# Product Change Notification

**Change Notification #:** 119748-00

**Change Title:** Intel® Server 1600W AC Common Redundant Power Supply AXX1600TCRPS, PCN 119748-00, Label, Power Supply Label Update

**Date of Publication:** November 28, 2023

### Power Supply Label

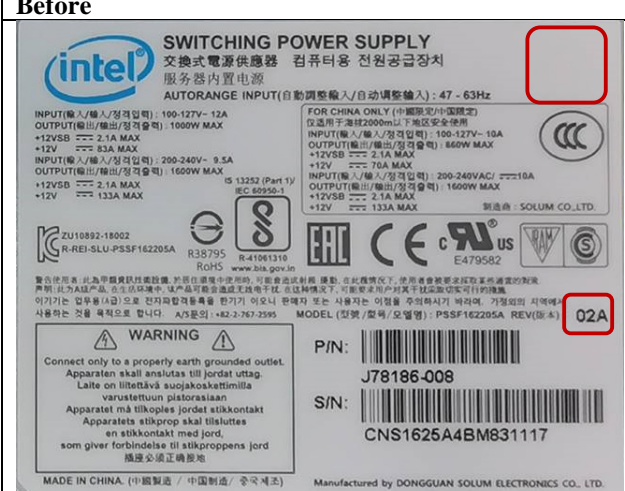
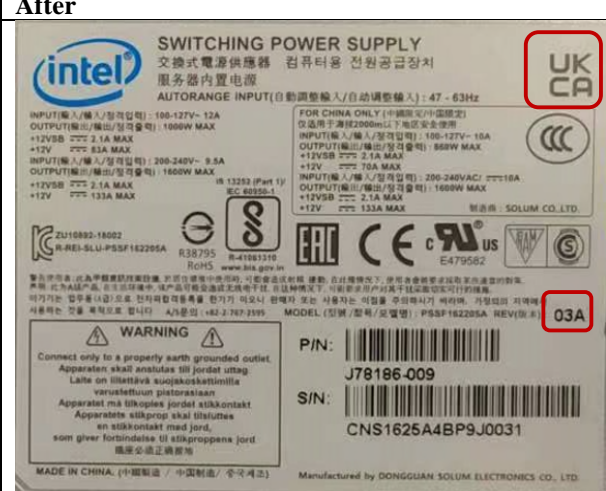
- Adding the UKCA certificate logo on the Power Supply Label
- The PSU revision will change from 02A to 03A
